TO: Mercedes-Benz Dealer Principals, General Managers, Sales Managers, Service Managers, Parts Managers	FROM: Gregory Gunther, Senior Manager, Vehicle Compliance and Analysis, Engineering Services
RE: <b>Recall Campaign Launch Notification</b> <b>Inspect 12V Starter/Alternator Wiring Harness</b> <b>MY22-23 SL (232 platform)</b>	DATE: November 3, 2023

Campaign No. 2023100014, November 2023

SUBJECT: **Model SL (232 platform)**  
**Model Year 2022-2023**

## **Inspect 12V Starter/Alternator Wiring Harness**

**Figure 1:** Inspect starter/alternator wiring harness near propeller shaft (**arrow A**), direction of travel (**arrow B**)

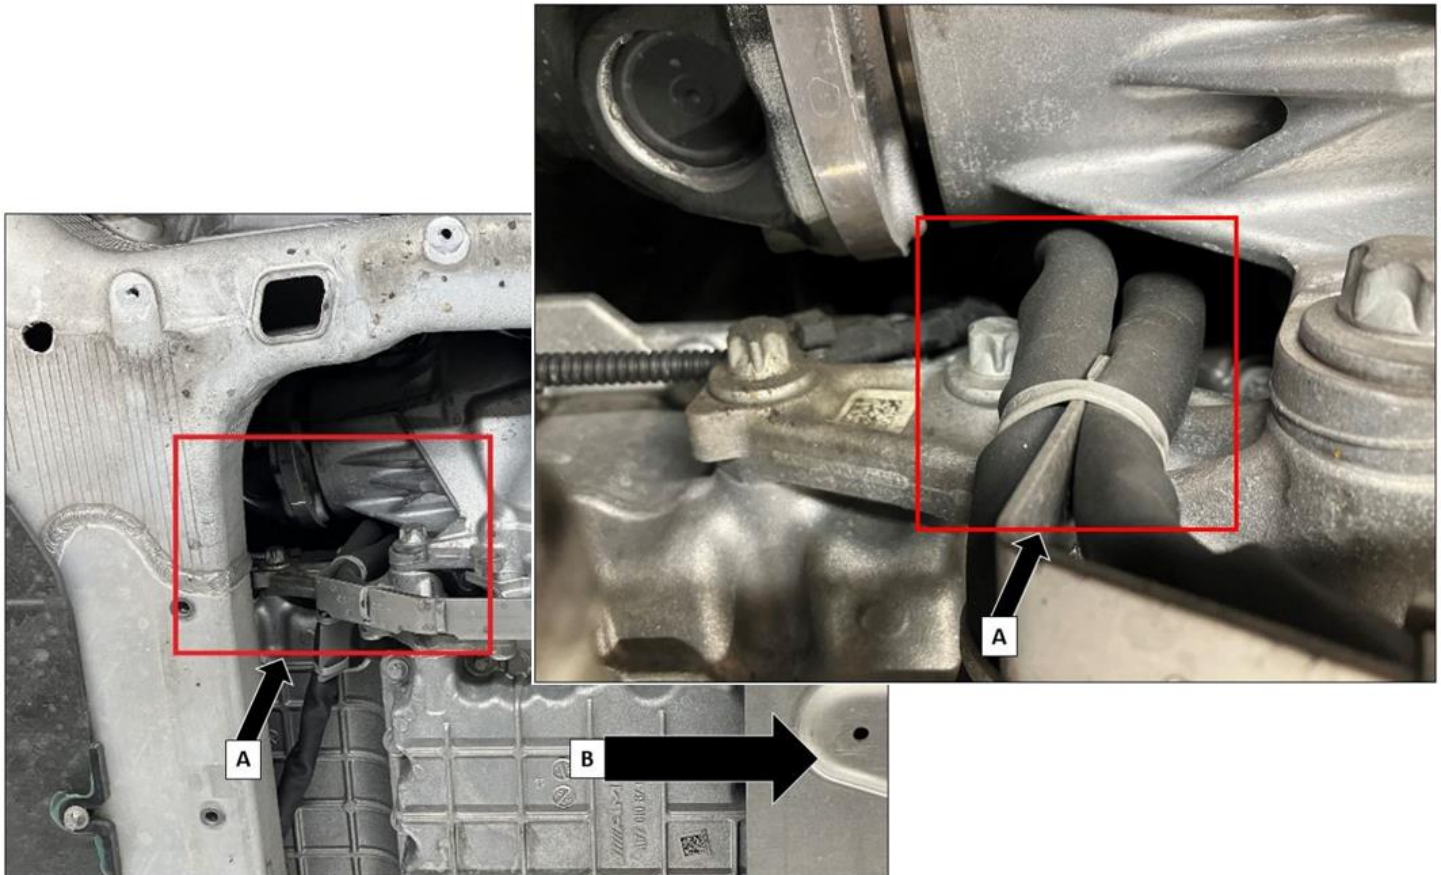
Mercedes-Benz AG (“MBAG”), the manufacturer of Mercedes-Benz vehicles, has determined that on certain Model Year (“MY”) 2022-2023 SL (232 platform) vehicles with the M177 engine, the routing of the 12V starter/alternator wiring harness might not meet specifications. The wiring harness might contact the drive shaft and chafe, which may result in a short circuit. A loss of propulsion cannot be ruled out, which could increase the risk of a crash. Additionally, due to the high electrical currents potentially flowing through this wiring harness, the temperature in this area might increase. Therefore, a risk of fire cannot be ruled out. An authorized Mercedes-Benz dealer will inspect and secure the 12V-starter/alternator wiring harness on the affected vehicles.

2. Check if the 12V starter/alternator wiring harness is too close to the propeller shaft and inspect it for damage near the propeller shaft (**A, Figure 1**).

- a. Starter/alternator wiring harness **not damaged**, carry out **Work Procedure 1**.
- b. Starter/alternator wiring harness **damaged**, carry out **Work Procedure 2**.

**Figure 2:** Install cable tie on starter/alternator wiring harness

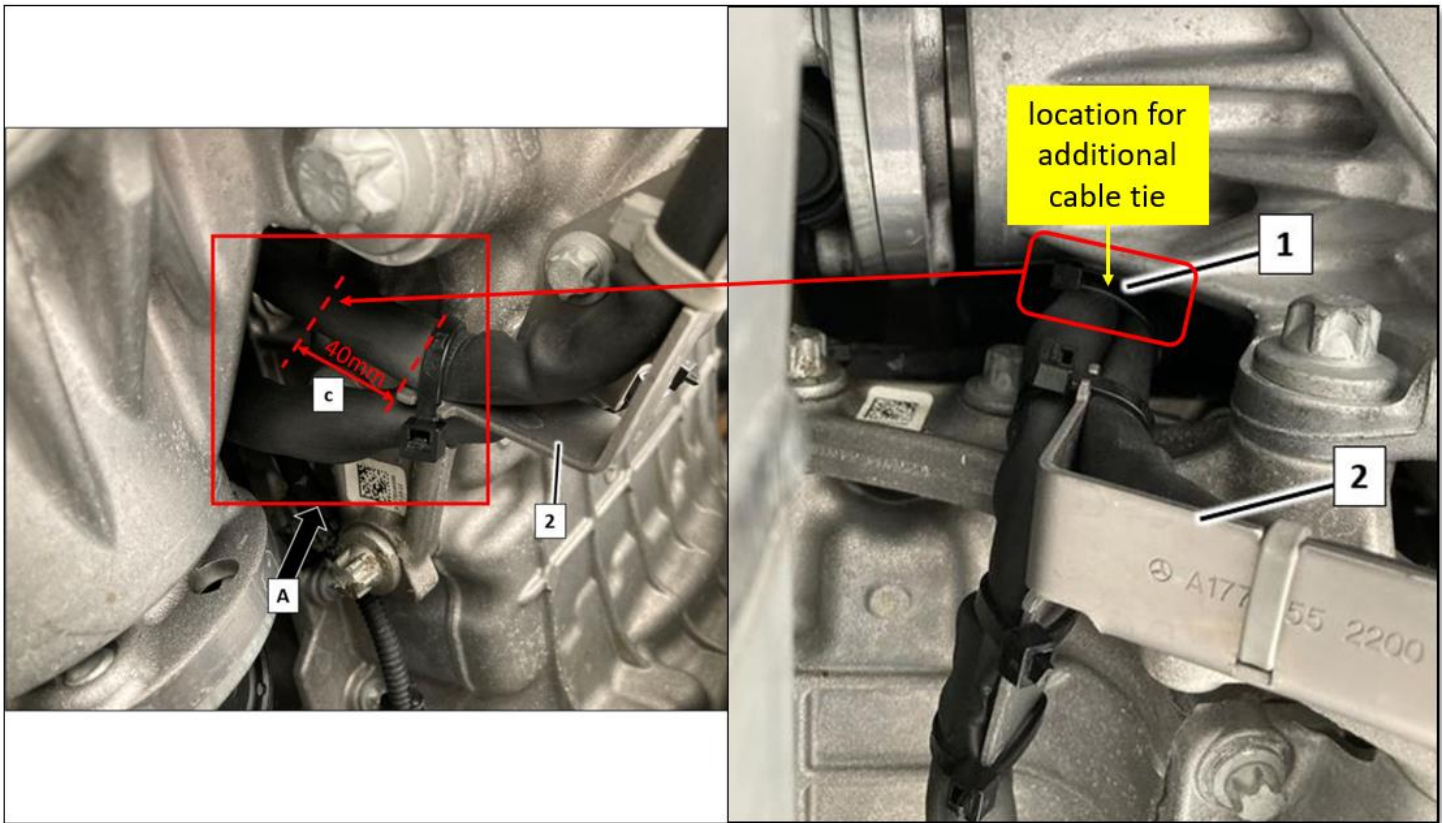
1. If the starter/alternator wiring harness is **not damaged**, install an additional cable tie (1, **Figure 2**) in area near the propeller shaft at approx. 40 mm (**dimension c, Figure 2**) above the bracket (2, **Figure 2**).
